Groundwater Transfer Review Summary Form

Transfer/PA # T- 14552

Application: T-14552

Applicant Name: Hans Nelson and Sons Nursery, Inc.

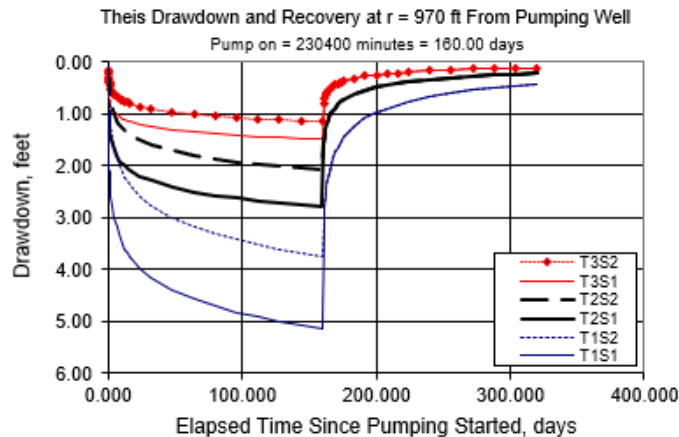
1. Basic description of the changes proposed in this transfer: This proposed transfer relates to certificate 50467, which authorizes the use of groundwater from a single POA (CLAC 980 ("POA-1")) to irrigate 14.2 acres (max. rate 0.11 cfs, ~50 gpm) in Clackamas County, approximately 3 miles southeast of Damascus.

This application proposes to add two APOA for certificate 50467:

- **"POA-2" (to be drilled)**
- **"POA-3" (to be drilled)**

- ☐ Yes ☒ No Comments: The nearest surface water source is a tributary to Johnson Creek located approximately 1600-1700 feet west-northwest of the application POA. However, this reach is not perennial and thus not subject to this analysis. Furthermore, relative to CLAC 980 (POA-1) the proposed location for POA-3 is only about 130 feet nearer to this intermittent stream course, and thus its proposed use would not be expected to cause any increase in additional interference even if the stream were a perennial reach.

**Theis Drawdown Analysis – Proposed APOA POA-3 to CLAC 989**

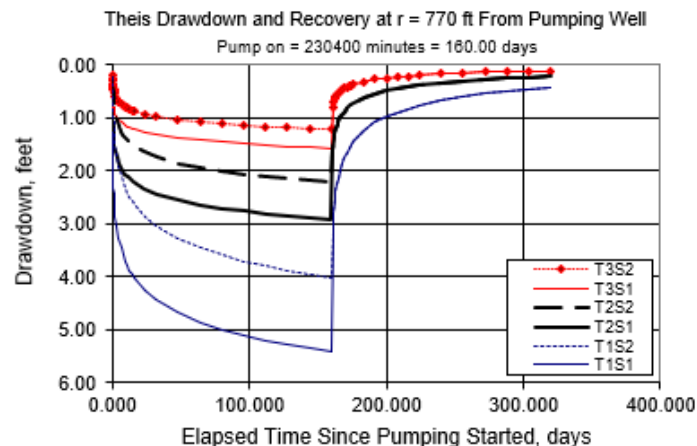
b) If yes, would this proposed change, at its maximum allowed rate of use, likely result in another groundwater right not receiving the water to which it is legally entitled?
☐ Yes ☒ No If yes, explain: To evaluate the potential additional interference with CLAC 989, a Theis (1935) drawdown analysis was completed. Aquifer parameters used for the analysis were derived from regional data and studies (Pumping Test Reports; Freeze and Cherry, 1979; McFarland and Morgan, 1996; Swanson et al., 1993). To provide a conservative analysis, it was assumed that both authorized POA CLAC 980 (POA-1) and proposed POA-3 would be independently pumped non-stop at the maximum authorized rate under certificate 50467 (0.11 cfs, ~50 gpm) up to the associated duty, which would be accomplished in about 160 days.

Results of the Theis comparative analysis indicate that additional interference with CLAC 989 would likely range from only about 1 to 4 feet based on these conservative pumping scenarios. This estimated low range of additional interference in nearby wells should ensure continued normal use of those wells; thus it is not likely that the proposed use will result in CLAC 989 or another similar groundwater right from receiving the water to which it is legally entitled.
